**Planning Commission
Staff Report
Project Plan Approval
Hearing Date: December 14, 2016**

ITEM 4 Premier Realty Investments LLC requests Project Plan Approval for a 63-unit townhome development located at approximately 1060 South 1100 East in the Low Density Residential Zone. **Spring Creek Neighborhood.** 16-0020PPA, Brian Maxfield, 801-852-6429

**Spring Creek Condominiums Subdivision
1040 South 1000 East
Provo, Utah**

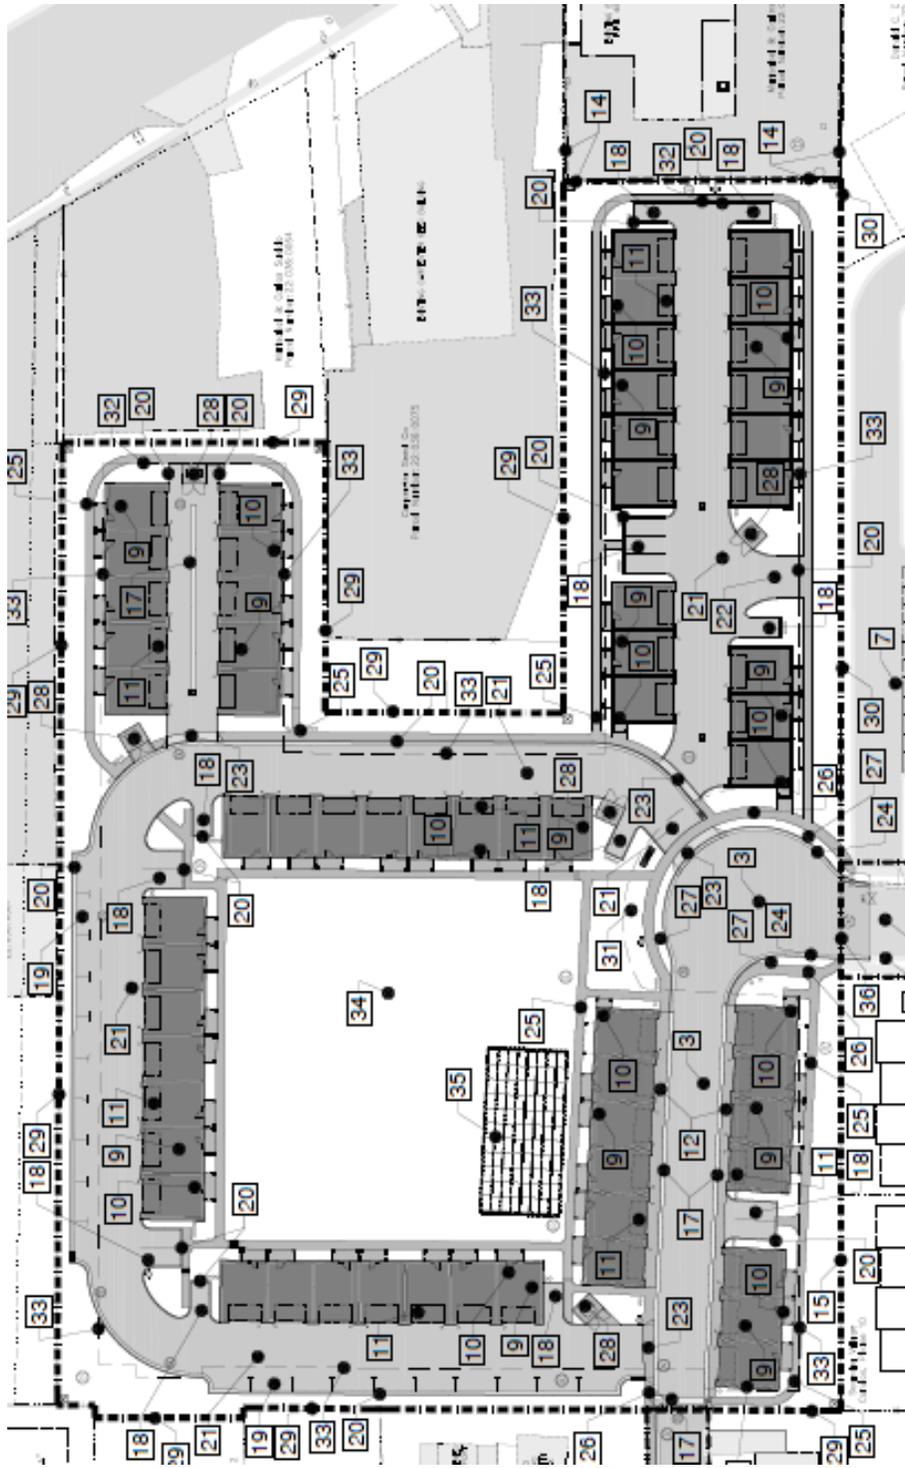
- A. Developer shall comply with the following conditions:
 - 1. 1060 South Street shall be continued as open access through the proposed Spring Creek development to 1000 East Street;

- 2. The four townhome units closest to the cul-de-sac that have the side elevations facing the cul-de-sac shall be designed to appear and function as front elevations including the front door;

- 3. The window on the basement level shall be removed from building plans or the development shall provide sufficient parking for 63 four-bedroom units;

- 4. The fencing along the southeast property line shall be open and three to four feet in height while fencing along all other property lines will be 6' masonry; and

Site Plan showing perimeter parking spaces

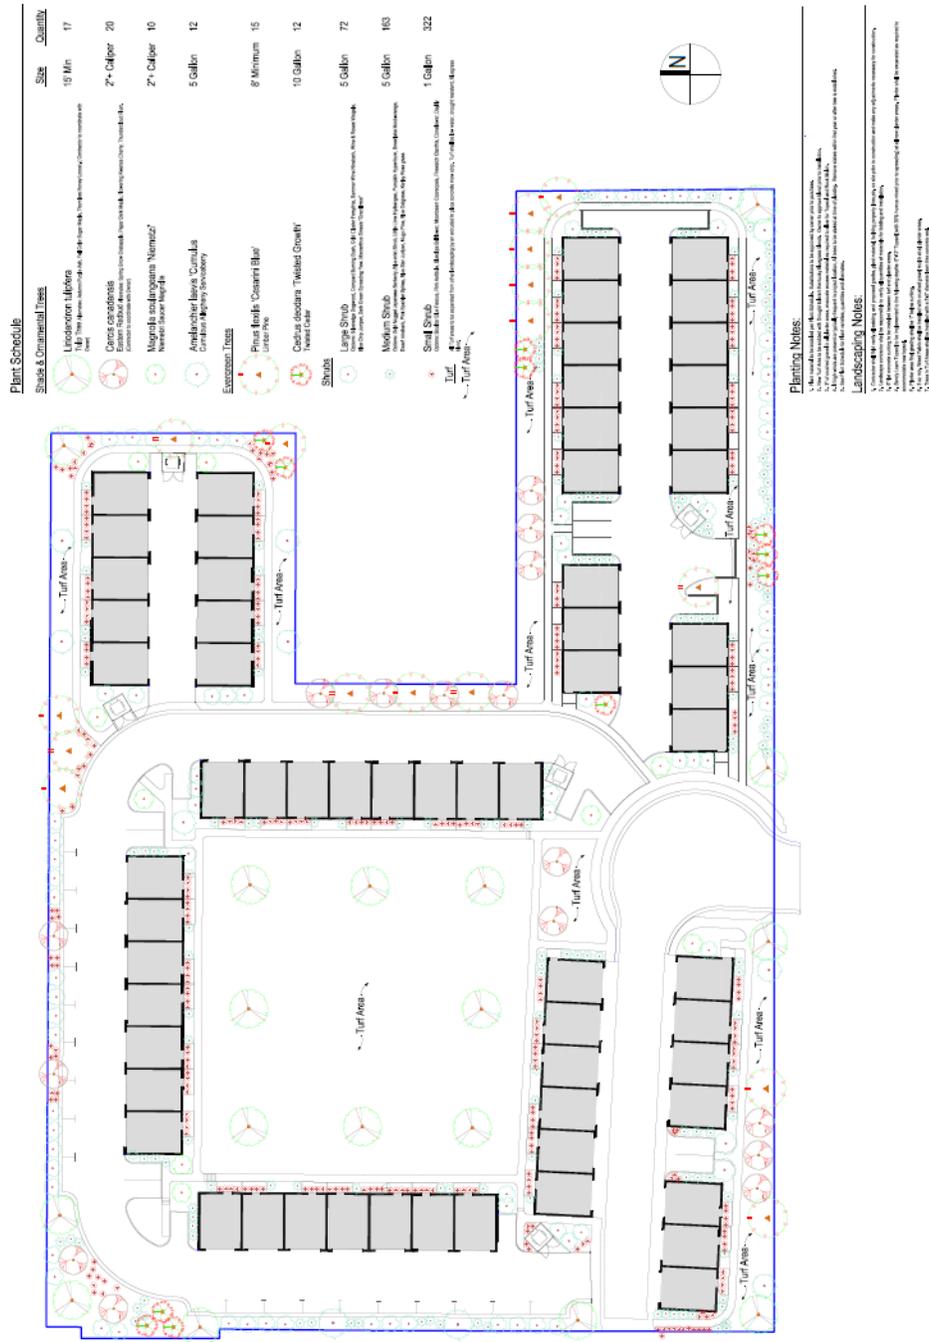
Staff has reviewed the proposed project plan for compliance with the LDR Zone, the Spring Creek Development Agreement, and other City Ordinance requirements. The only design difference in the project from the concept plan approved as Exhibit "B" with the Development Agreement is in the parking. The project plan indicates an additional 20 spaces which have been placed along the outside western and northern perimeter of the circular access of the project. Staff believes this additional parking will help address many of the parking concerns expressed at previous public hearings regarding this project.
